## **Appendix IS-3**

### Geotechnical Feasibility Report

## SOILS REPORT APPROVAL LETTER

TRACT: 1988 // LANDER TRACT NO. 2 (M P 4-57)  
LOT(S): 6-8 // 1-4 & 8  
LOCATION: 6450 - 6562 W SUNSET BLVD // 1420-1454 N. Wilcox Ave. and 1445-1447 & 1413-1443 N Cole Pl.

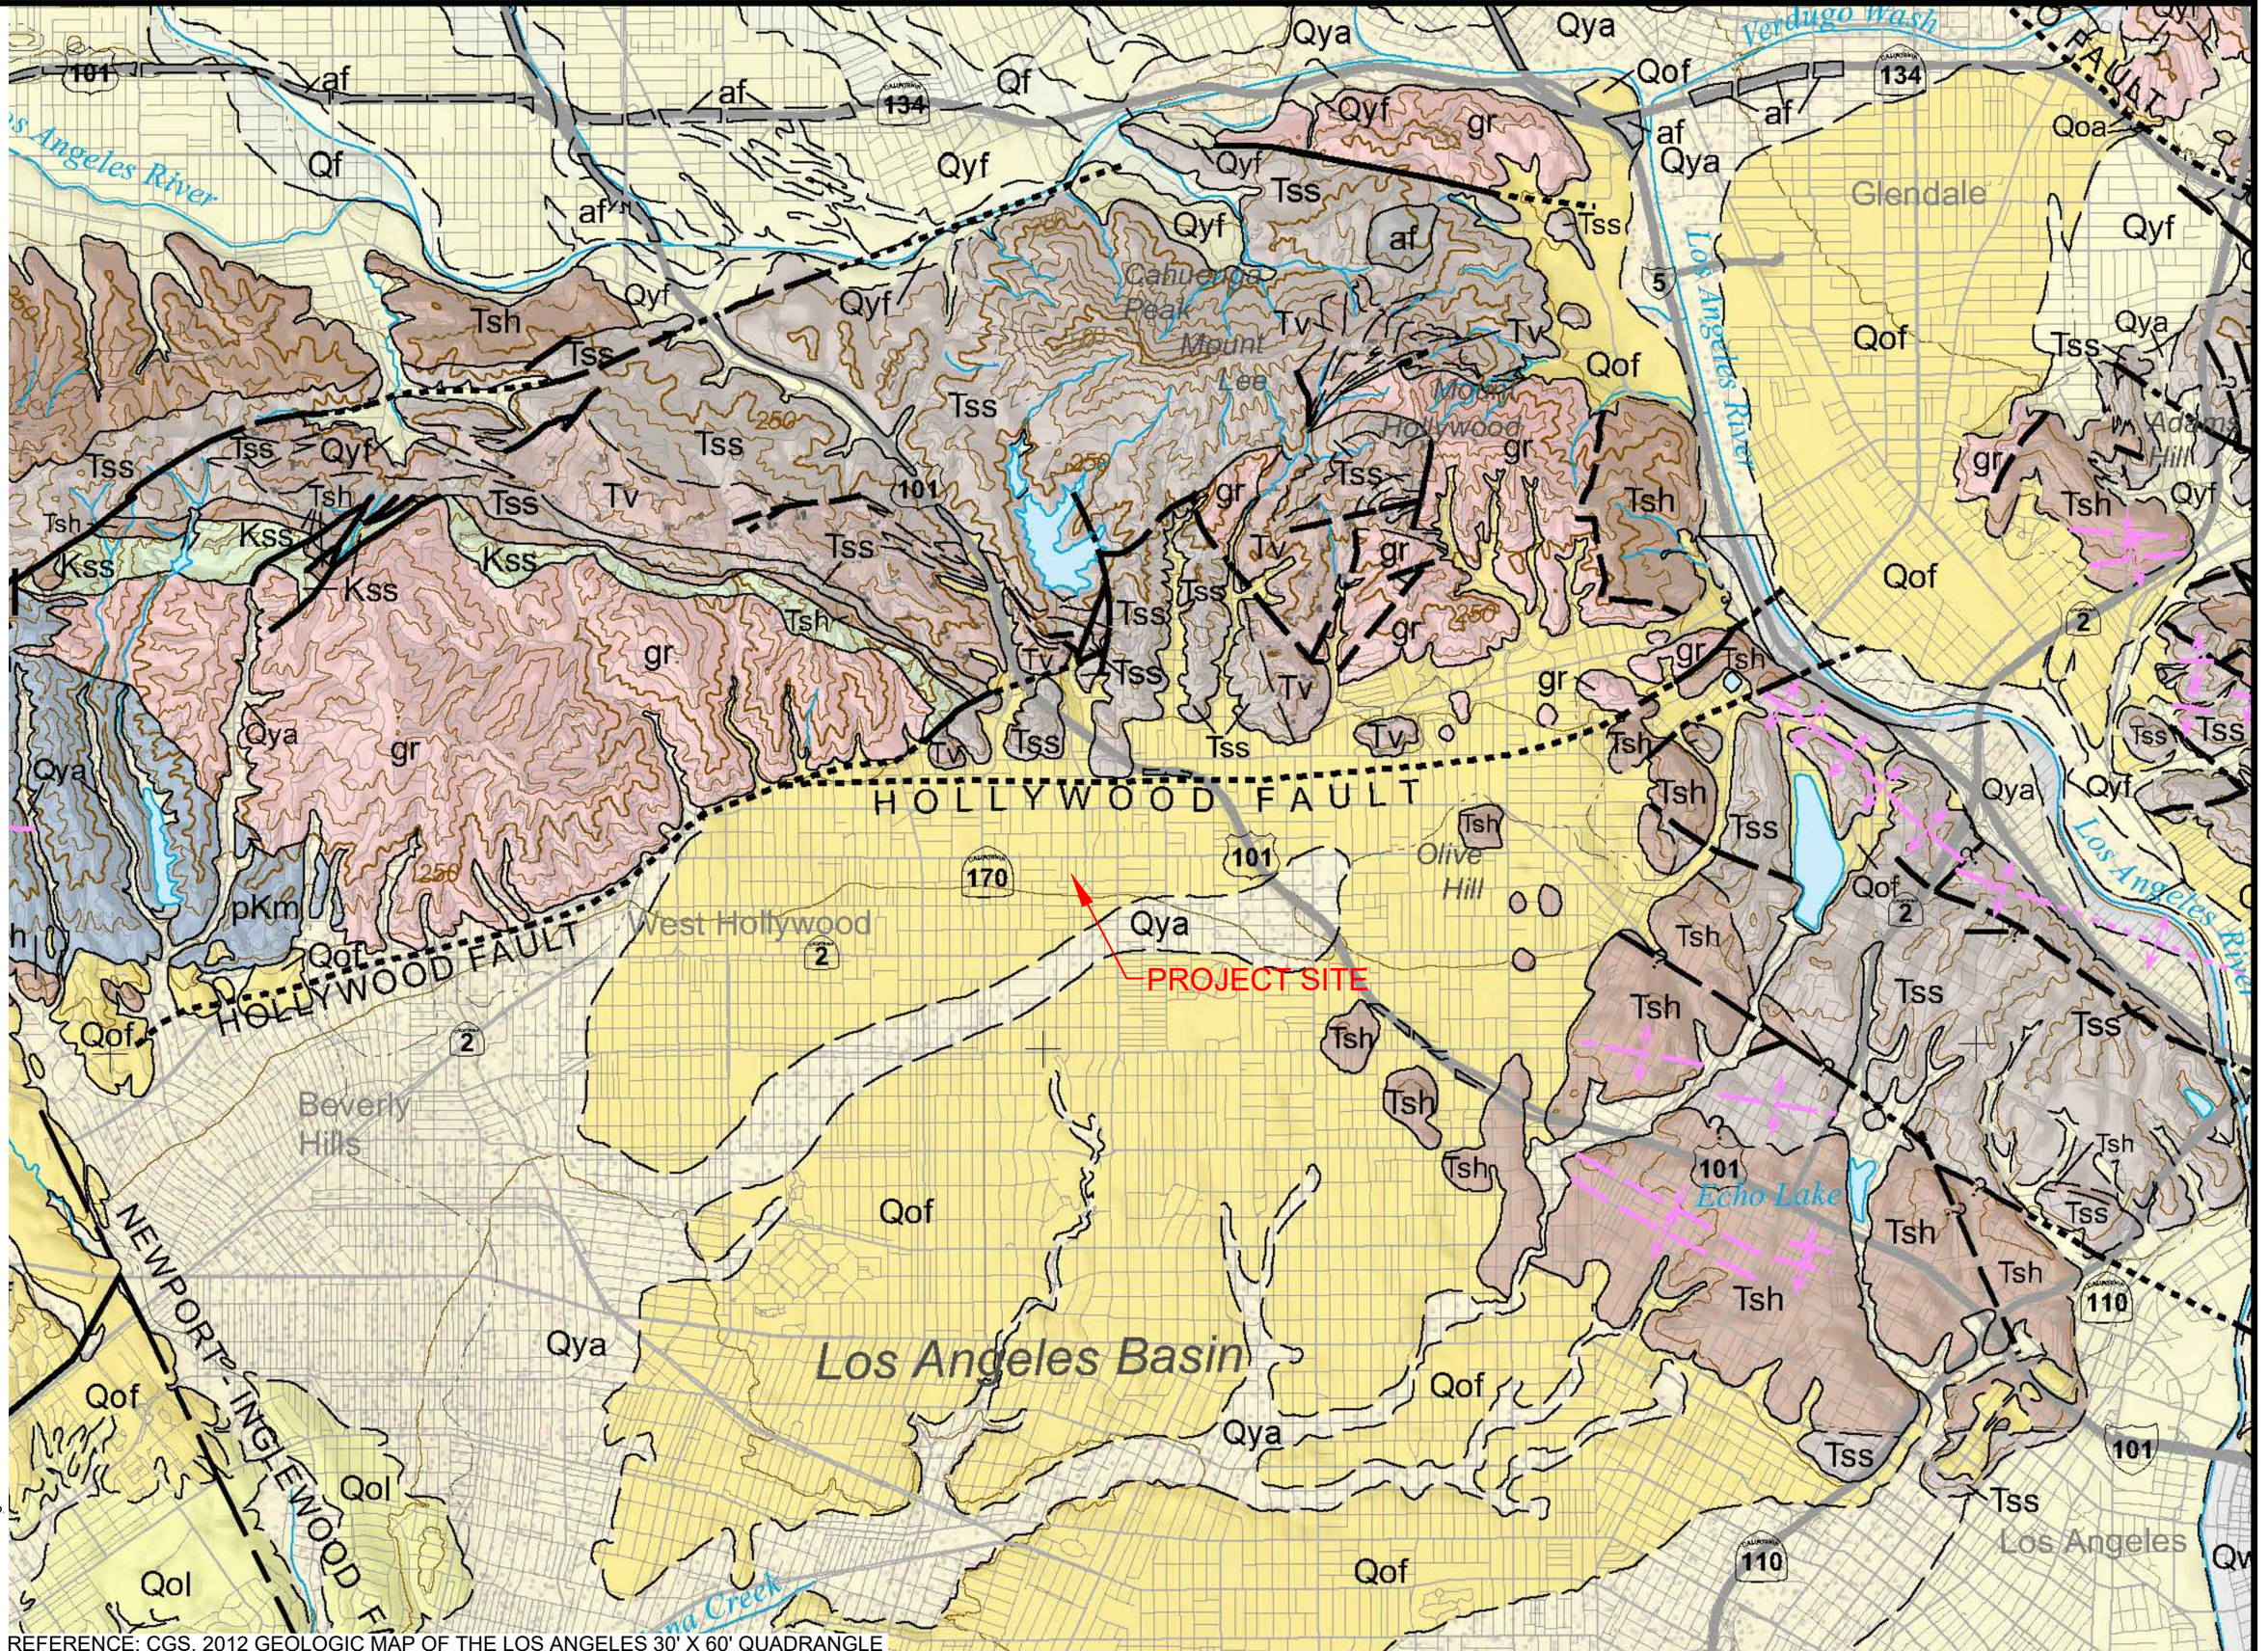
In the report Figures, Figure 4 – Cross Section A-A’ should be amended such that the cross section is labelled with A’ at the southern extent of the section.
